UNITED STATES
NUCLEAR REGULATORY COMMISSION
REGION II
101 MARIETTA STREET, N.W.
ATLANTA, GEORGIA 30303

MEMORANDUM FOR: Darrell G. Eisenhut, Director
Division of Licensing, NRR

SUBJECT: COMMENTS ON DRAFT APPENDIX A TECHNICAL SPECIFICATIONS,
GRAND GULF UNIT 1, DOCKET NO. 50-416

ENCLOSURE

FIGURE 5.1.1-1

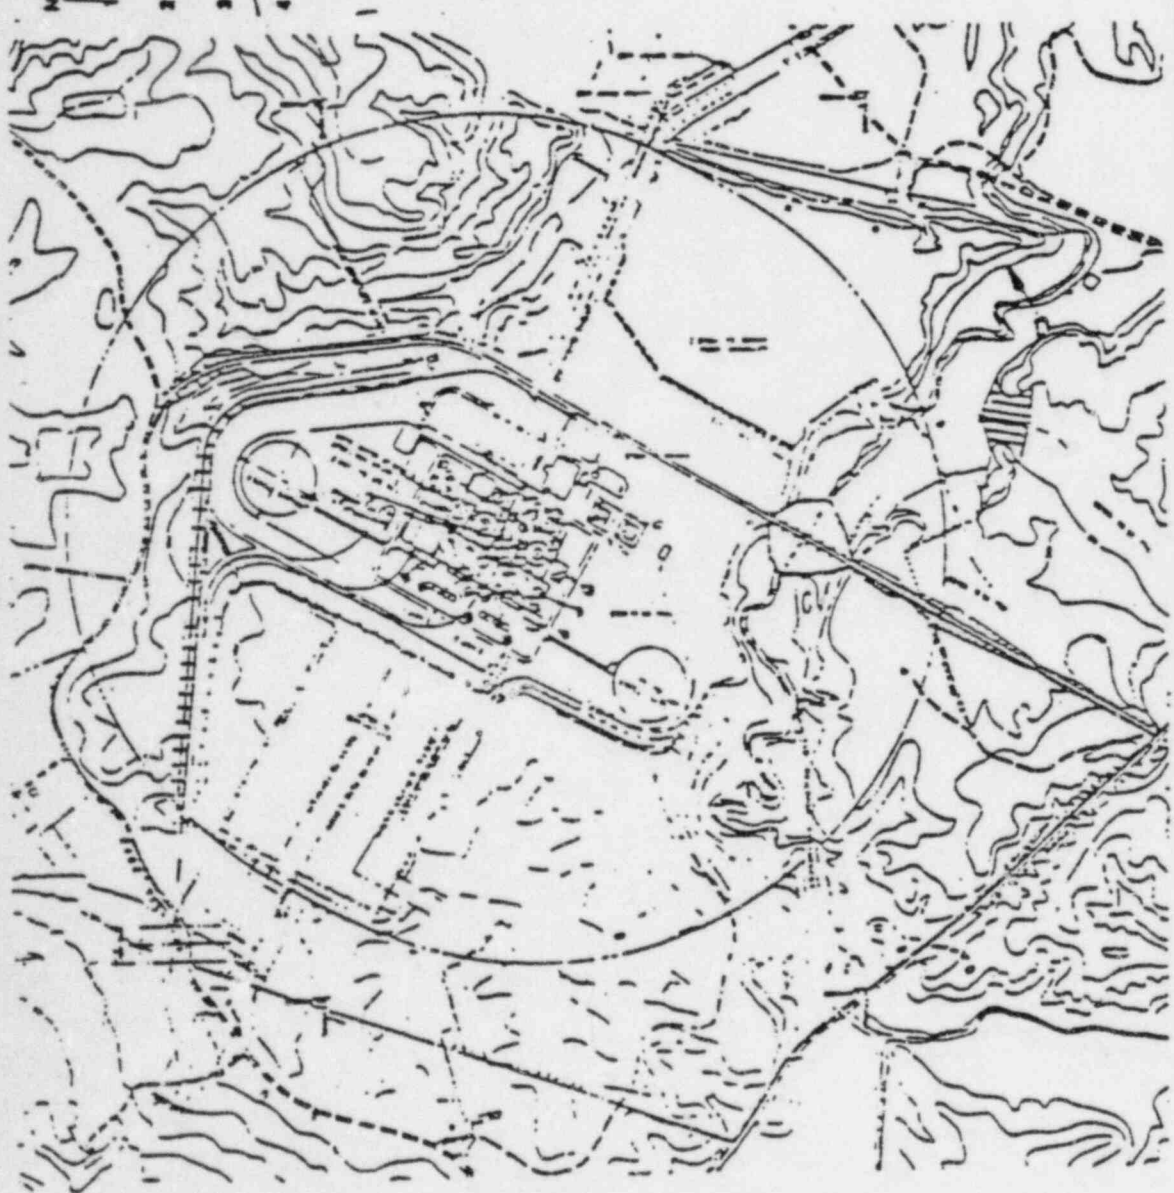
DISCUSSION: This change involves correction of terminology and a typo. Under Note 3 for Figure 5.1.1-1 the reference to Figure 5.1.4-1 should be changed to 5.1.3-1. The words "Unrestricted Area Boundary" should be changed to "Effluent Release Boundary" in 4 places.

JUSTIFICATION: The terminology "Unrestricted Area Boundary" is not appropriate for gaseous and liquid effluents and is inconsistent with the terminology used in the Emergency Plan. The appropriate terminology is "Effluent Release Boundary". The Effluent Release Boundary is shown in Figure 5.1.3-1 instead of the non-existent Figure 5.1.4-1.

FIGURE 5.1.3-1

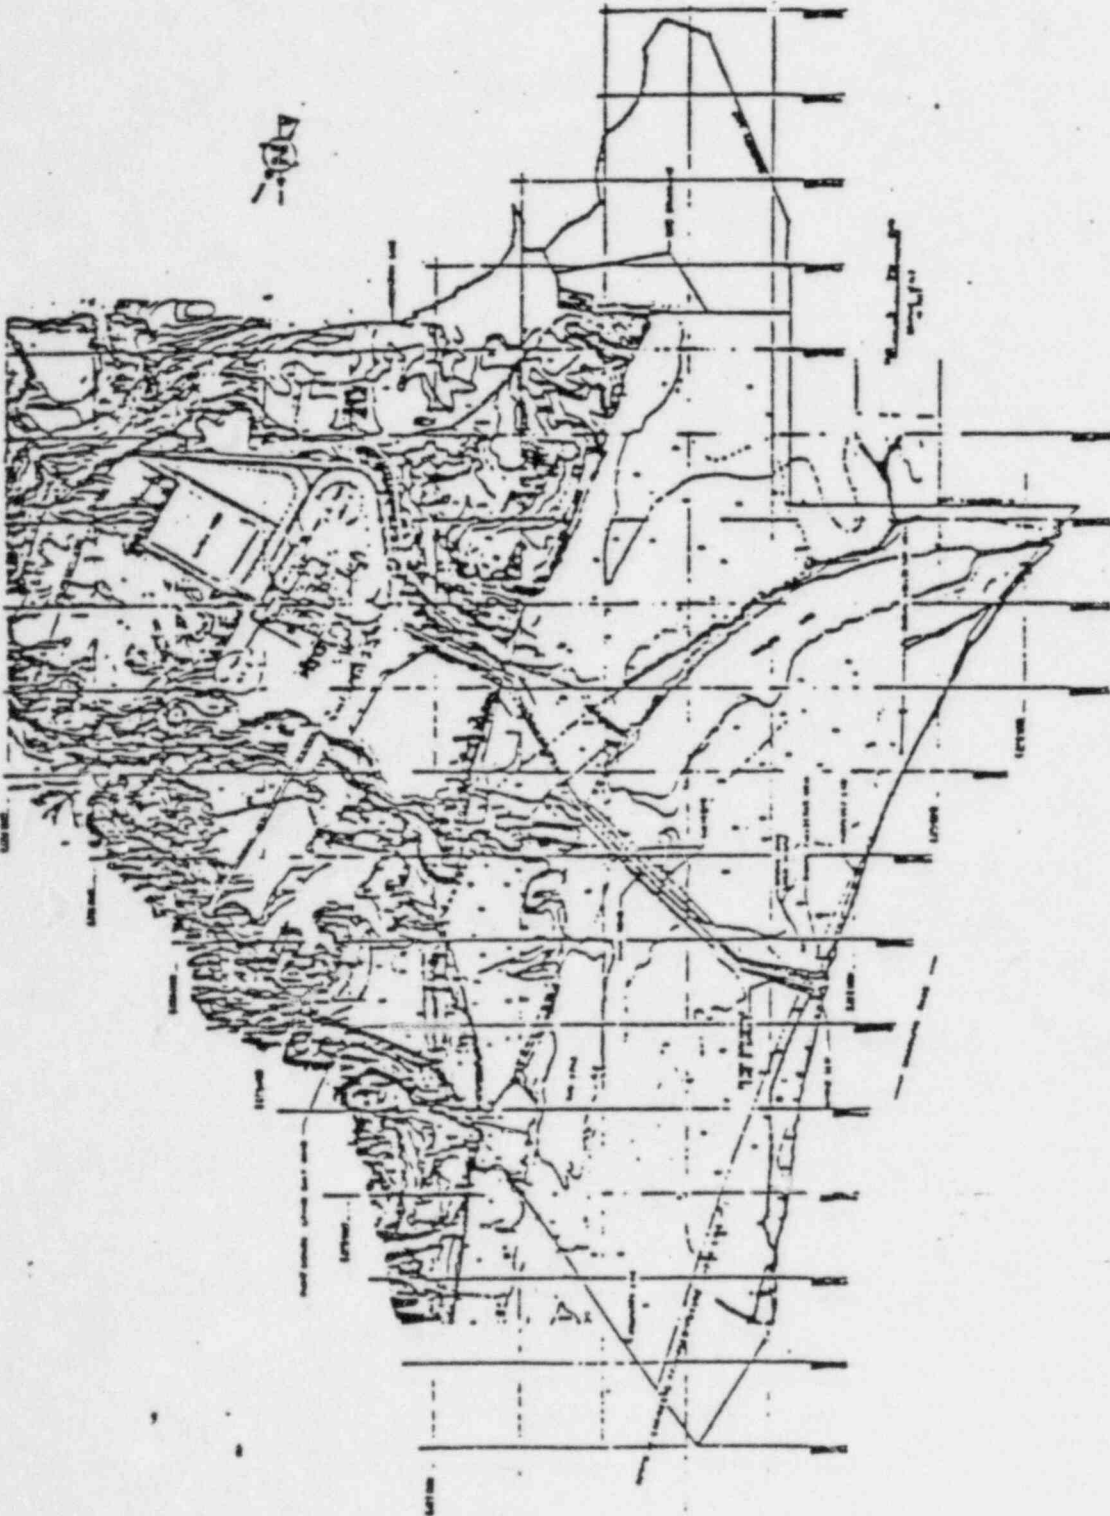
5.1.3 The ^{effluent release}~~unrestricted area~~ boundary for gaseous effluents and for liquid effluents shall be as shown in Figure 5.1.3-1. The gaseous effluent release points are shown in Figure 5.1.1-1.

This change is not acceptable. If the change were made there would still be a number of terms of this type in the Grand Gulf Tech Specs that are not defined:
